SUMMARIZATION OF NEW APPENDICES (B, C, D, E, F, G, H, I)

DATE: June 15, 2026

RE: Supplemental Public Comments and Risk Assessment regarding the Proposed 20 MGD Wastewater Treatment Facility

LOCATIONS UNDER CONSIDERATION: Sites 1 through 7 — Mann Road, Berea Church Road, and Coles Ferry Pike corridor, Lebanon, TN

Exhibit C-1: 0.5-mile, 1.0-mile, and 2.0-mile rings centered on 3230 Mann Road, plotted on the TDEC Water Wells Desktop Application map. Each dark dot represents a permitted private water well in the TDEC database.

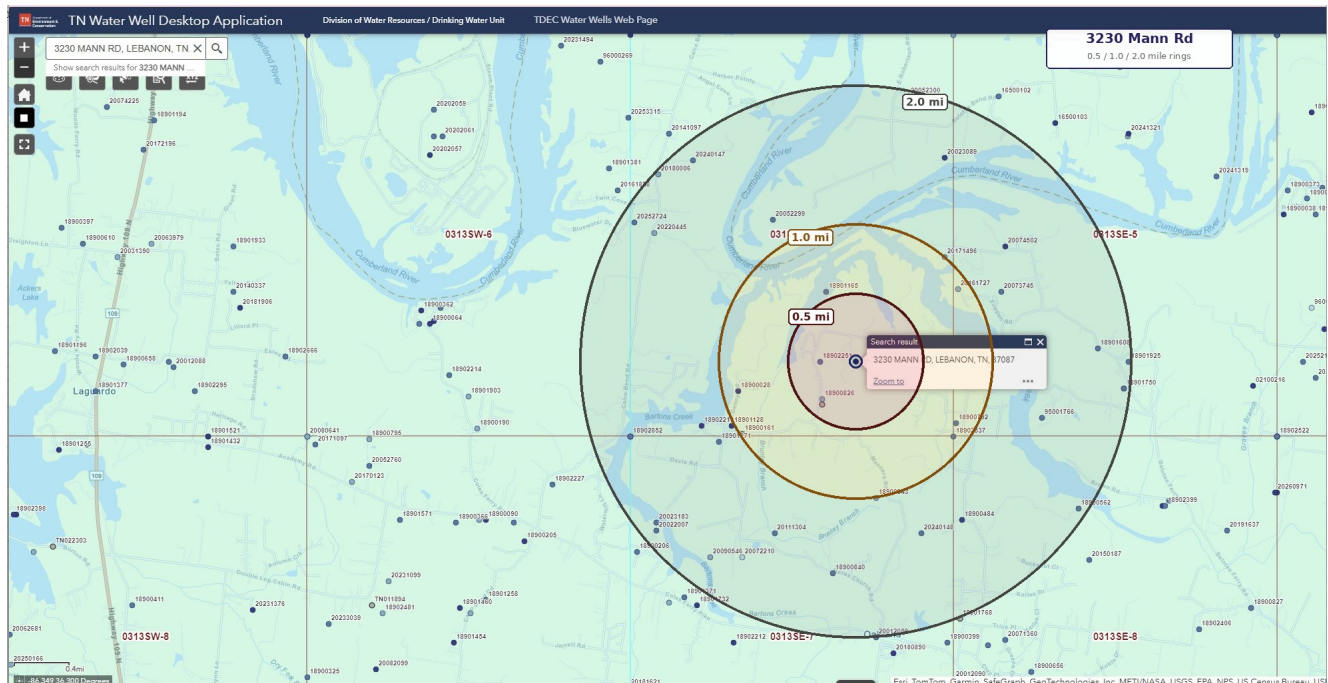
A query of the Tennessee Department of Environment and Conservation (TDEC) Water Well Locations public database identifies **a minimum of 38 permitted private wells within the 2-mile contamination radius** surrounding the proposed Mann Road and Berea Church Road footprint. Of these:

- **6 wells are located within 0.5 miles** of a proposed site, including a well at 1079 Berea Church Road (Coster) situated approximately 850 feet (0.16 mi) from the Mann Road site;
- **16 wells are located within 1.0 mile** of a proposed site;
- **38 wells are located within 2.0 miles** of a proposed site, the outer boundary of the karst contamination radius identified in Section VI.

The geographic distribution of these wells, with concentric 0.5-mile, 1.0-mile, and 2.0-mile rings, is depicted in Exhibit C-1 below. Recorded uses include residential drinking water (32 wells), agricultural and irrigation (9 wells), and geothermal heat pump (3 wells). The Site Selection Committee has not, to the petitioners' knowledge, entered these figures into the public record.

Important caveat: The figure of 38 wells is a minimum. The TDEC Water Well Locations database includes only those wells for which a licensed driller filed a report. Wells drilled prior to the

establishment of mandatory driller reporting, owner-drilled wells, and wells for which a driller's report was never filed are not represented. The actual number of households dependent on private well water within the contamination radius is reasonably expected to be materially higher.

- Formally request a hydrogeological study from a qualified third party documenting (or refuting) hydraulic connectivity between the proposed site footprint and the LUD well field;
- Require coordination with the LaGuardo Utility District Board of Commissioners as a prerequisite to any further consideration of the Mann Road and Berea Church Road addresses;
- Enter the well-count data and accompanying ring map (Exhibit C-1) into the official public record of the site selection proceedings, and supplement it with an independent staff verification against the most current TDEC Water Well Locations database;
- Provide written notification to each identified well owner, and to all LUD ratepayers, of the proposed siting and the karst-aquifer contamination pathway described in Section VI of the principal statement.
